## Firmware 2.06.3 bug list:

## List of bugs/improvement requests

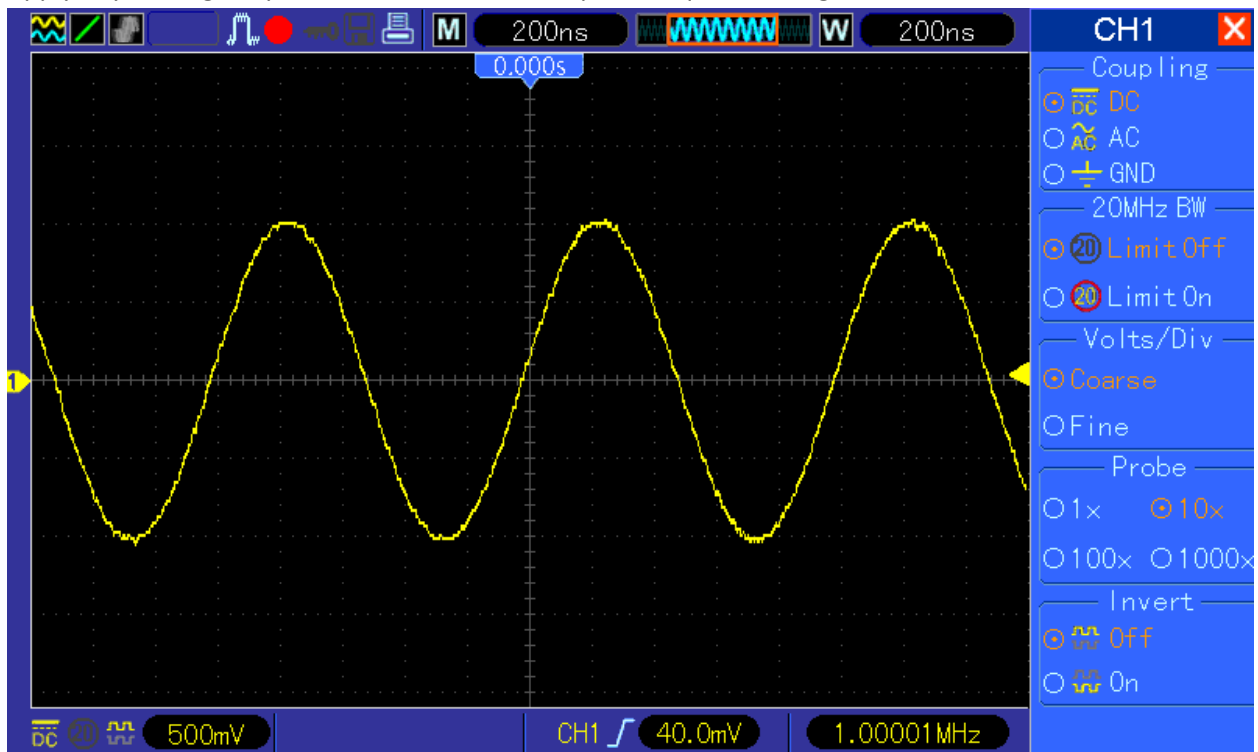
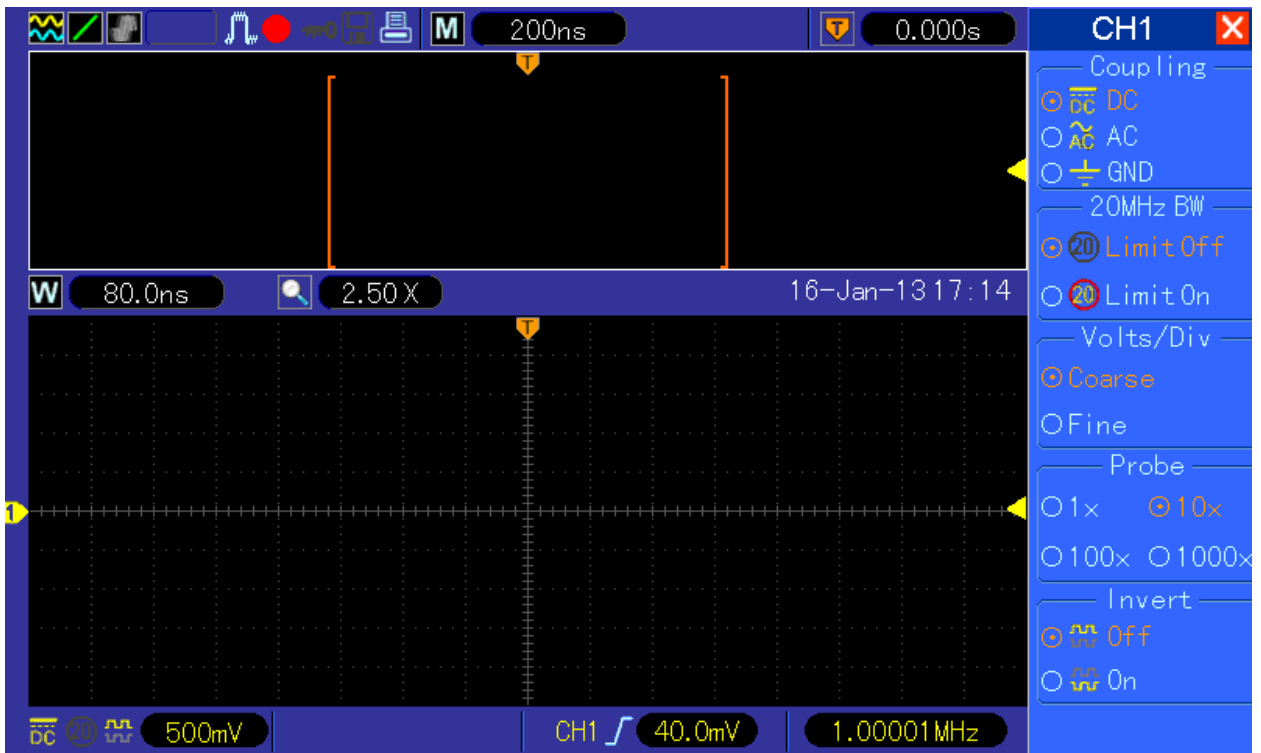
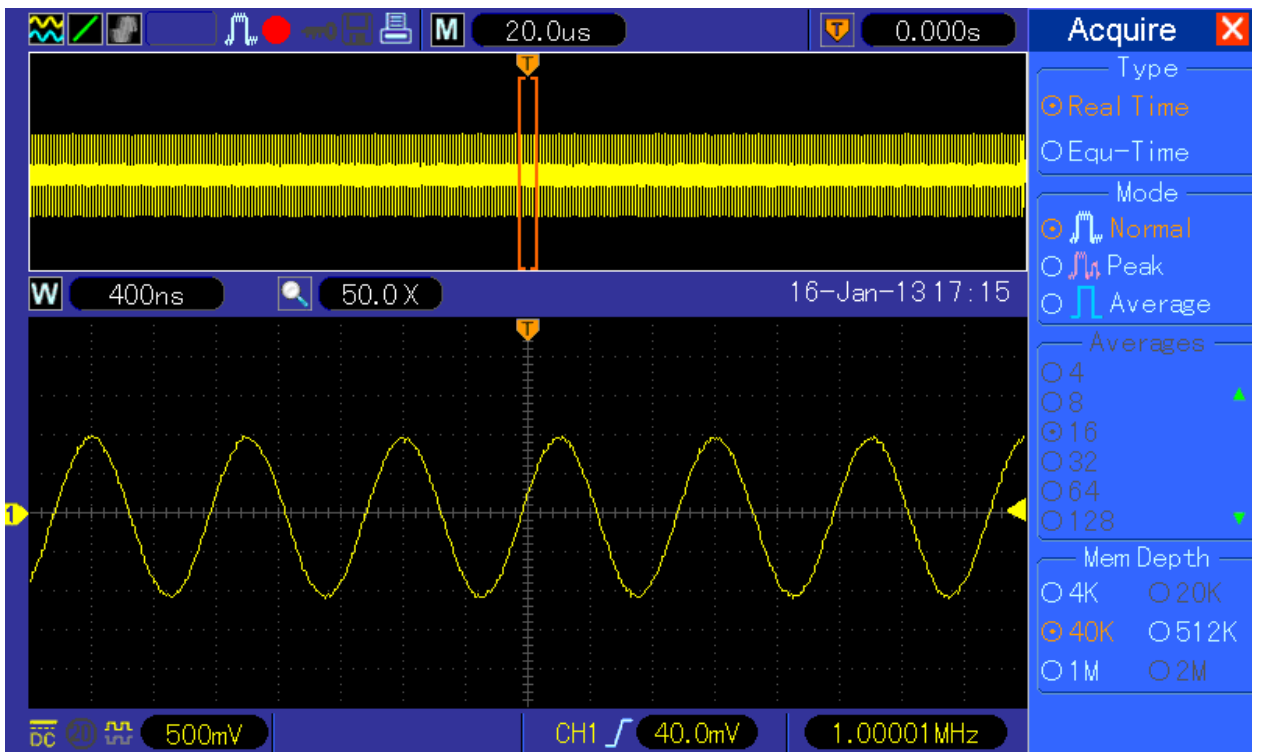
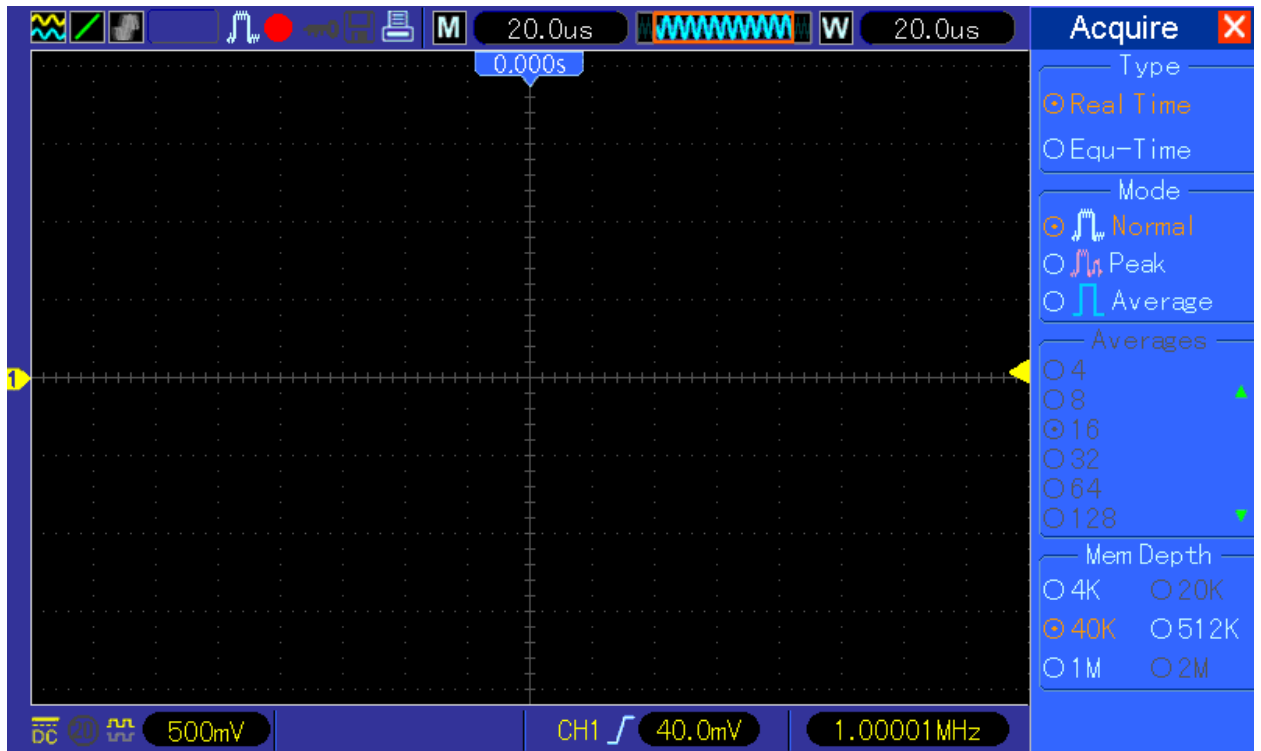
41. **This bug was already there in 2011, then it has been fixed. Now it's again there.**  
**This is one of the DSO basic functions; this bug is really annoying and need to be fixed FIRST.**

Apply any test signal, push "STOP" button to stop the Acquisition, e.g.:

now change to Dual Window by pushing F7, the Waveform disappeared from the Screen!!!:

This bug is not dependent on Memory Depth nor Timebase position, here another one example.

This time apply any test signal while in Dual Window and push "STOP", the Screen is e.g. like :

now push F7 to go back to Single Window mode – the Waveform disappeared from Screen :
